EEG-29

**EVALUATION OF THE SAFETY ANALYSIS REPORT
FOR THE WASTE ISOLATION PILOT PLANT PROJECT**

Environmental Evaluation Group

May, 1985

Figure 2.7-23 Structure Contours on Top of Castile Formation

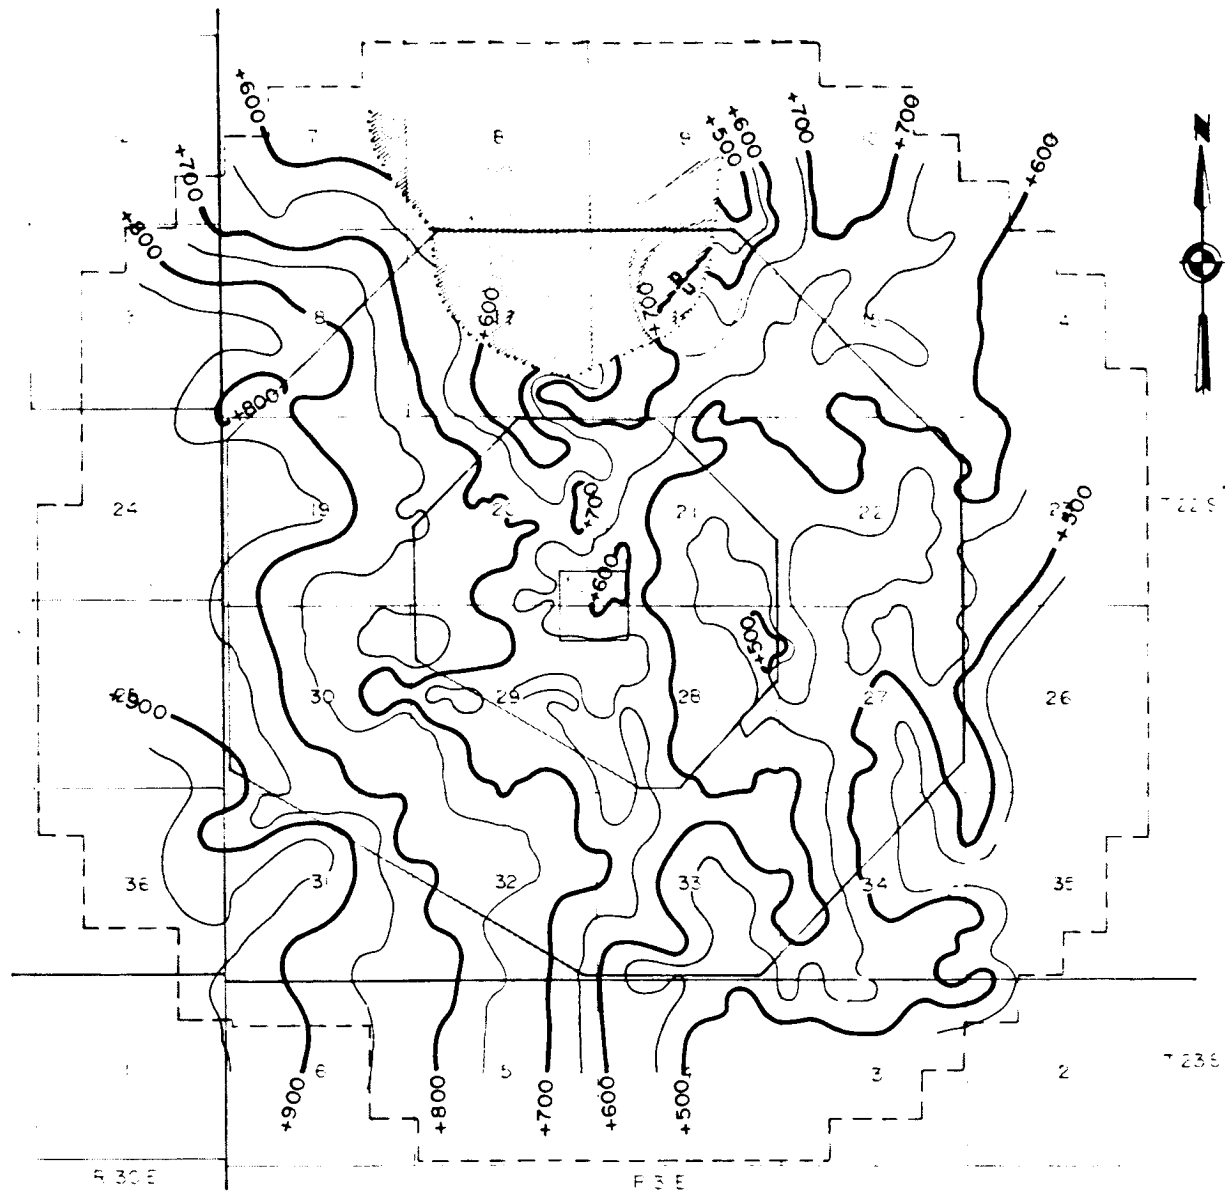
EEG called attention to the inaccuracies of the SAR's data and discussion with respect to numerous brine reservoirs in the Castile formation and their location and possible interconnection.

Certain of the reservoirs may be interconnected and cover a broad area including the WIPP site, however the data on the reservoirs at ERDA-6 and WIPP-12 suggest that these reservoirs are not connected. There remains the possibility that the WIPP-12 brine extends beneath the WIPP repository.

DOE responded by deleting Figures 2.7-23, 2.7-24, and 2.7-25, on the basis of Westinghouse "reinterpreting" the seismic profile data. The "disturbed zone" was considered a misnomer, and instead the zone was referred to as an "anomalous zone." The fact that the disturbed area did not extend into the Salado was considered by DOE to be evidence that it was not active "instability" and therefore would present no threat to WIPP. The MB-124 depression and the WIPP-12 anticline also were not considered problems for WIPP but rather reflect slow geologic processes of general interest. As a result of the State/DOE
